**NOTICE
OSHTEMO CHARTER TOWNSHIP
Zoning Board of Appeals**

Property: 5938 Venture Park Drive, parcel number 3905-25-153-140

Request: Site plan review for a new office building.

Project Name: Wolff Financial

SITE PLAN
 1" = 20'-0"

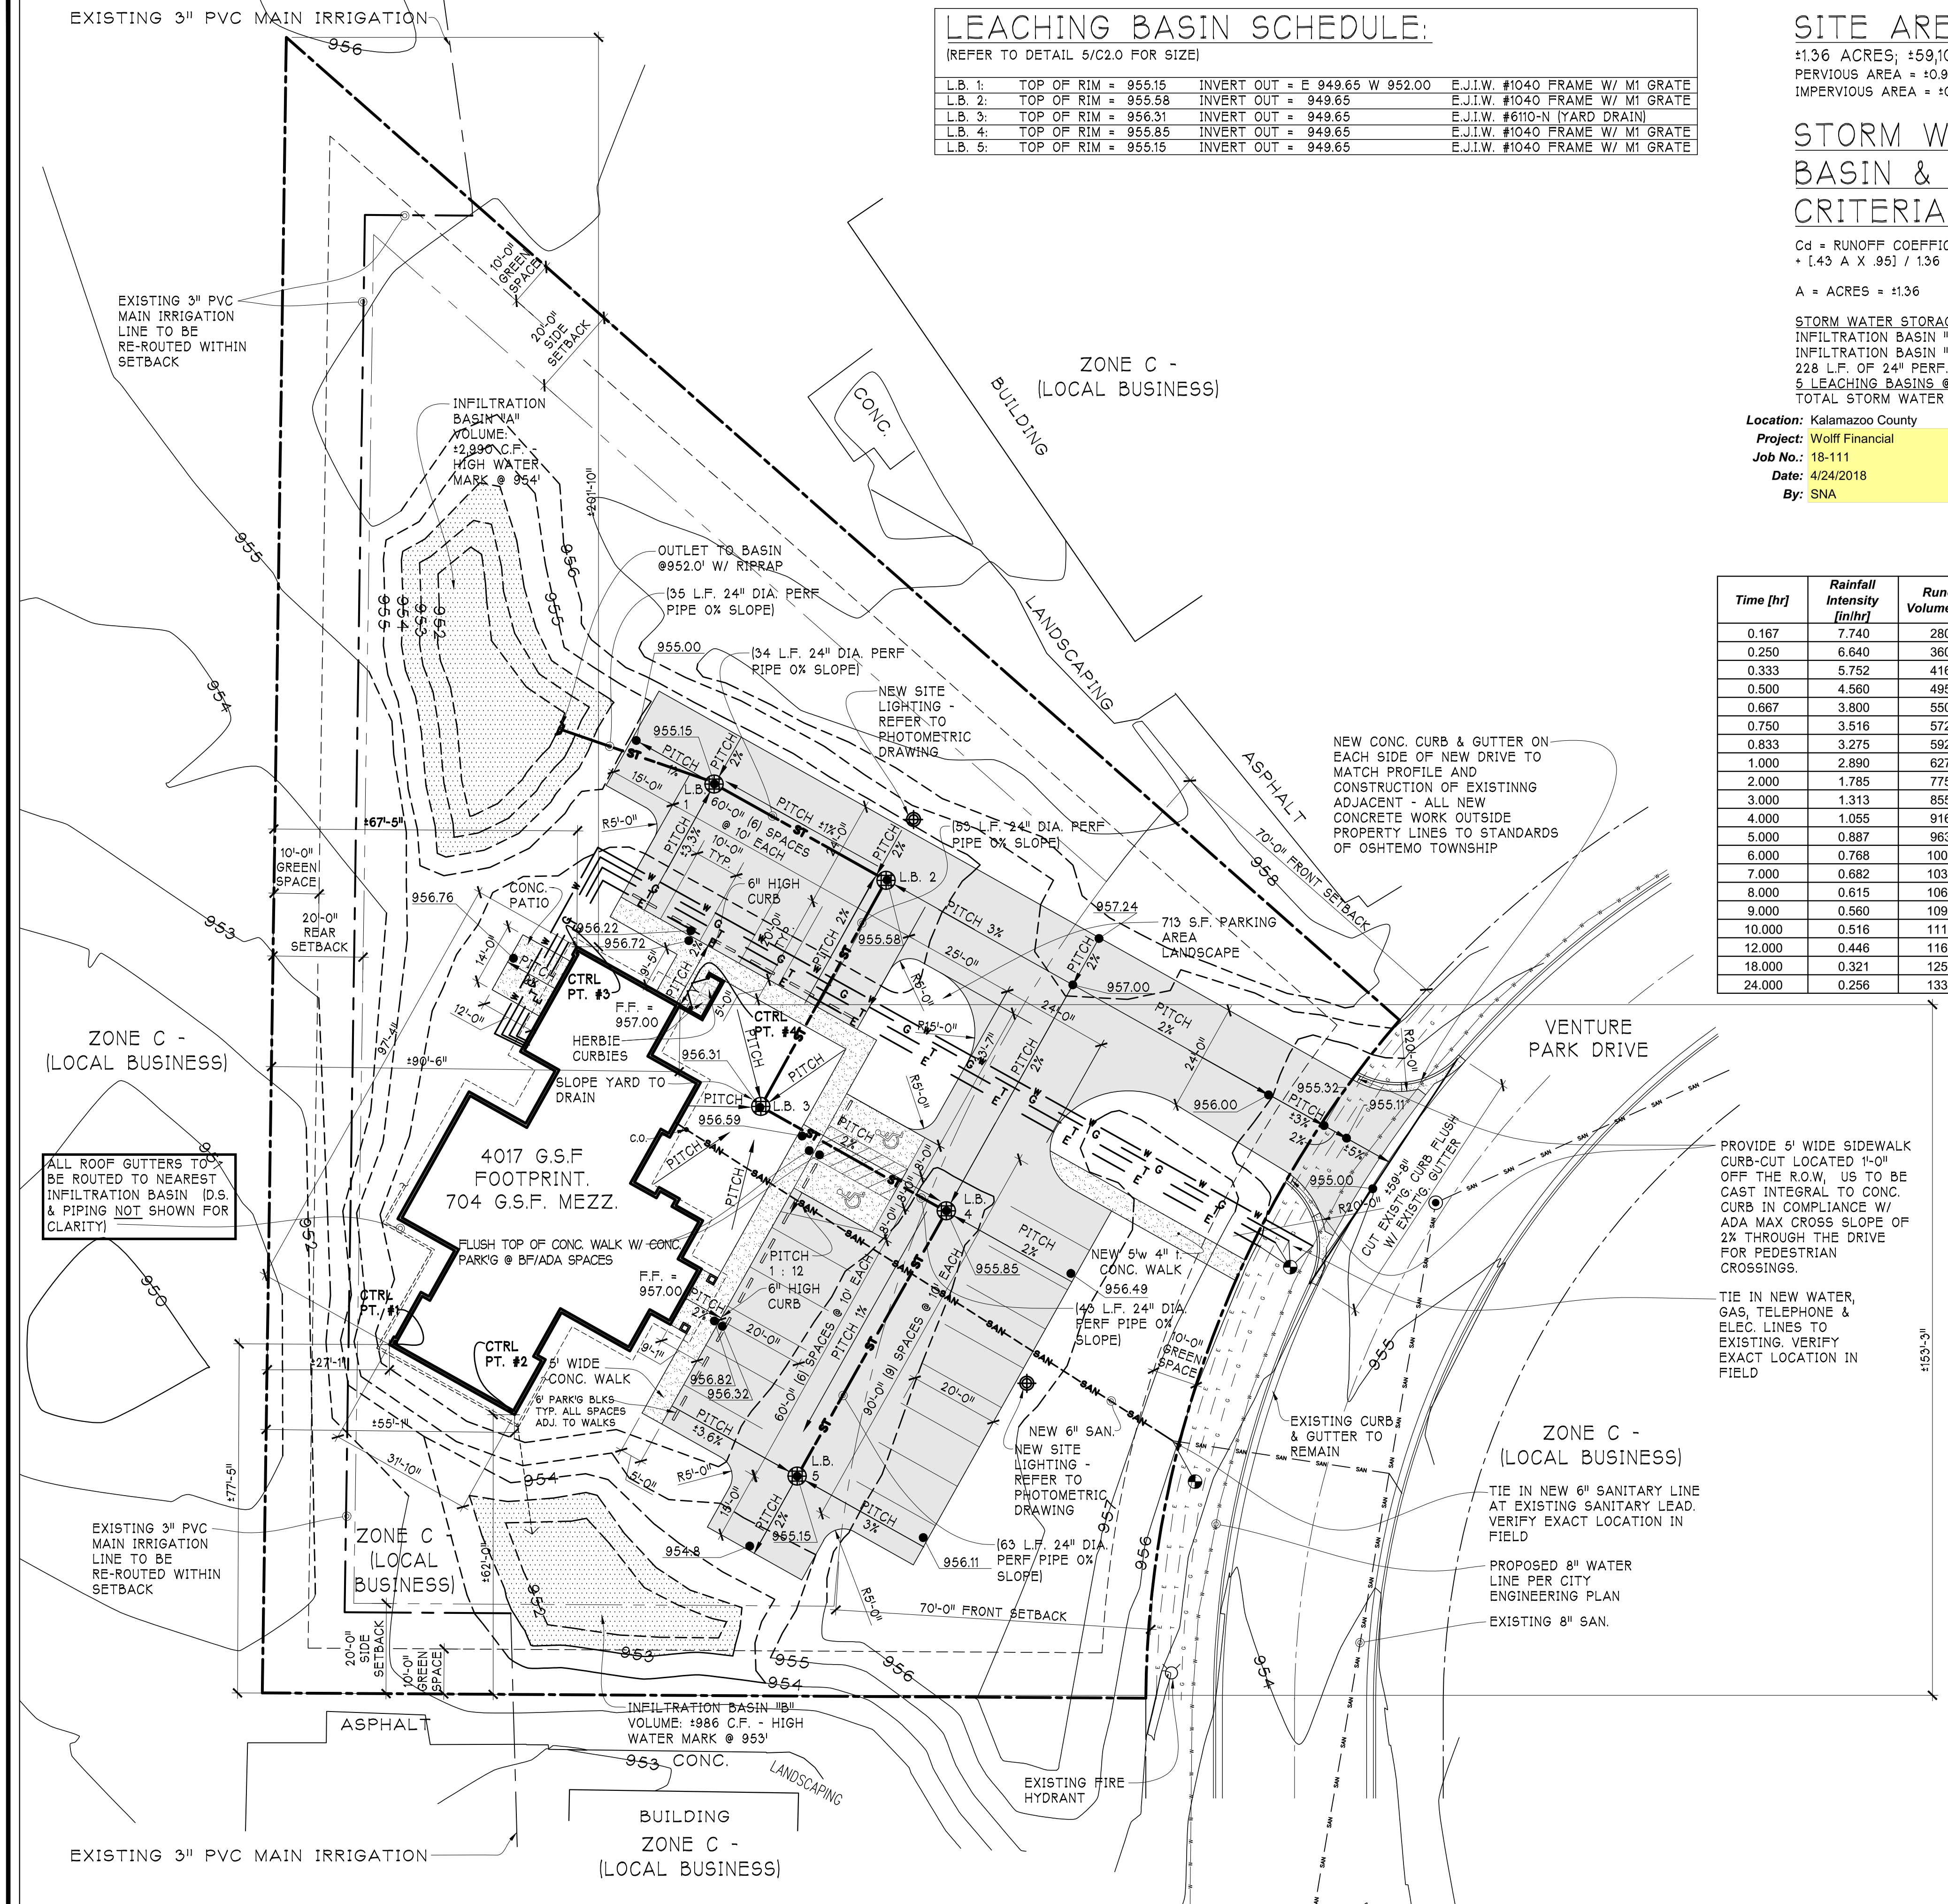
On site, vehicle parking will be located in front and east side yards. Staff calculates a minimum of 23 parking spaces required onsite, per section *68.000: Off Street Parking* of the Zoning Ordinance. The site plan indicates 17 spaces located at the front of the building and six within the east side yard for a total of 23 spaces. Per *Section 68.300.D*, the accessible spaces are shown as concrete.

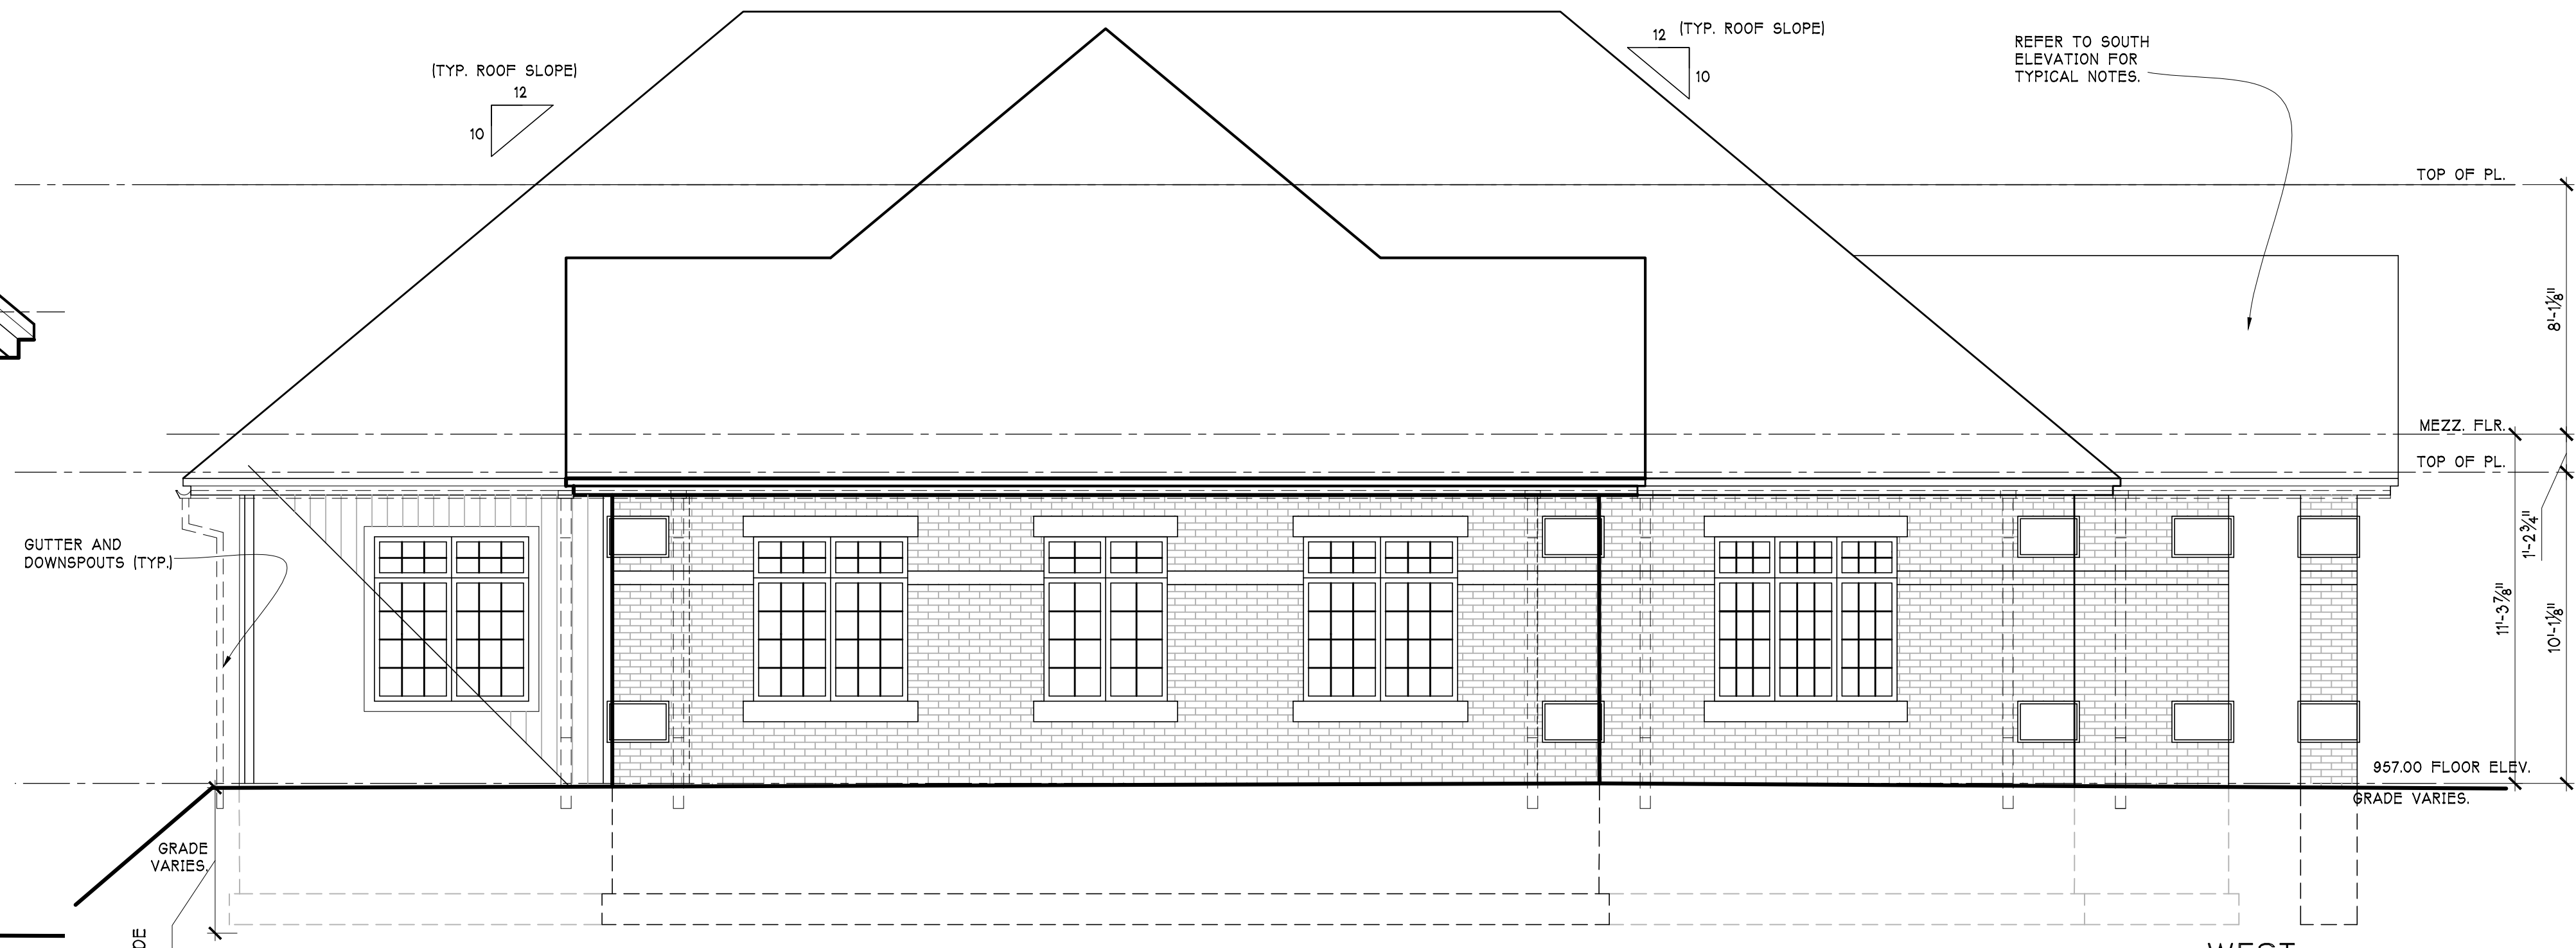
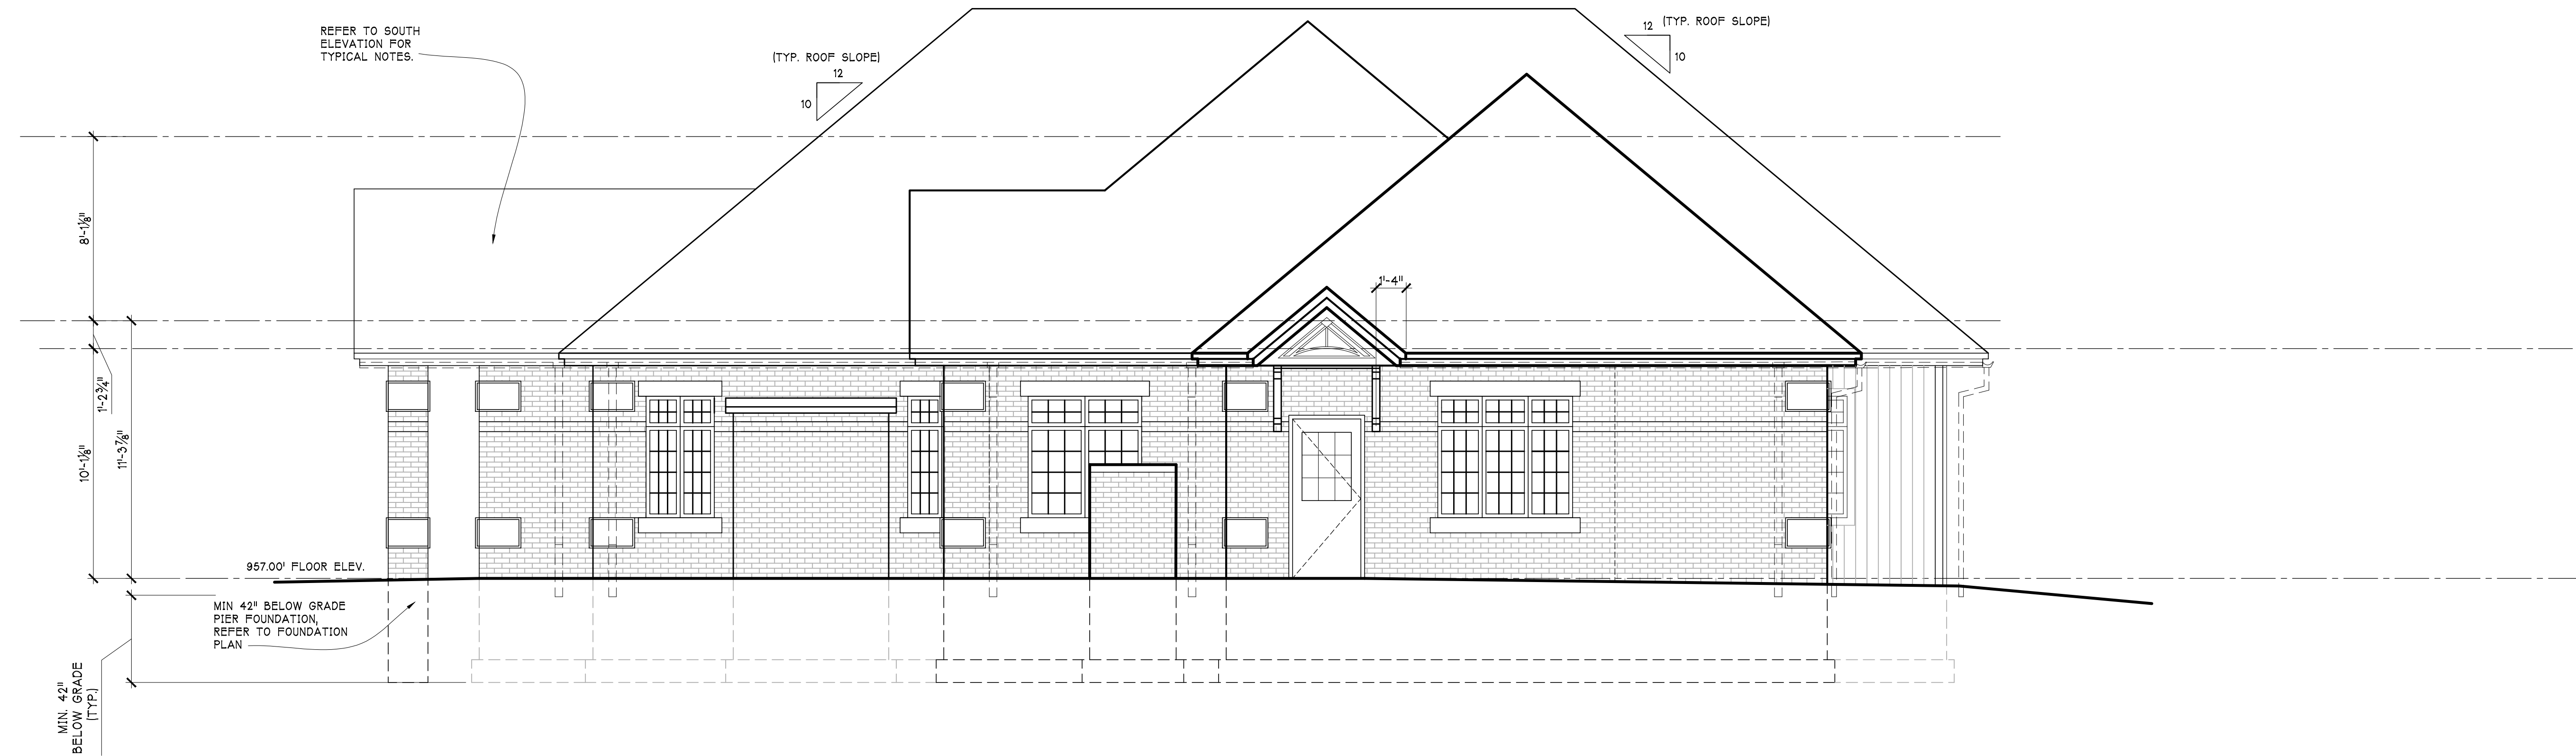
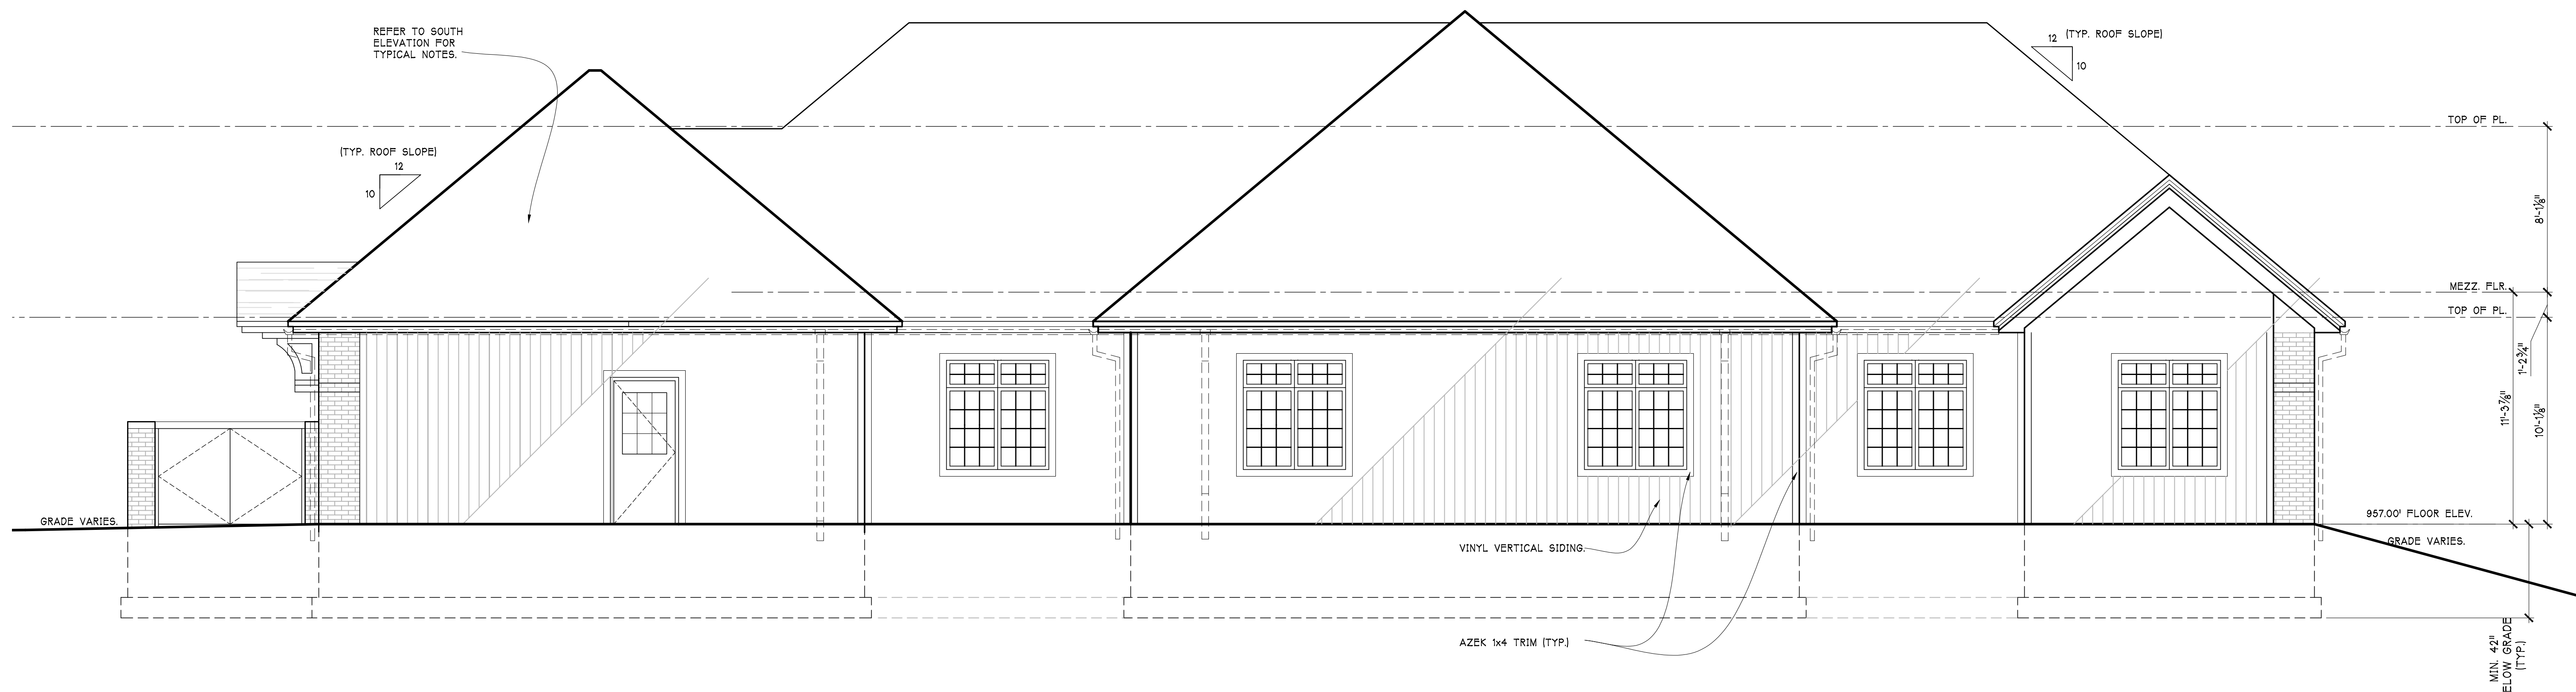
Exterior wall material colors are required on the site plan per *Section 82.600.C.3.b*. The applicant has indicated that while exterior wall materials have been chosen, their colors have not yet been decided. A revised set of elevation drawings will need to be provided with the exterior colors indicated.
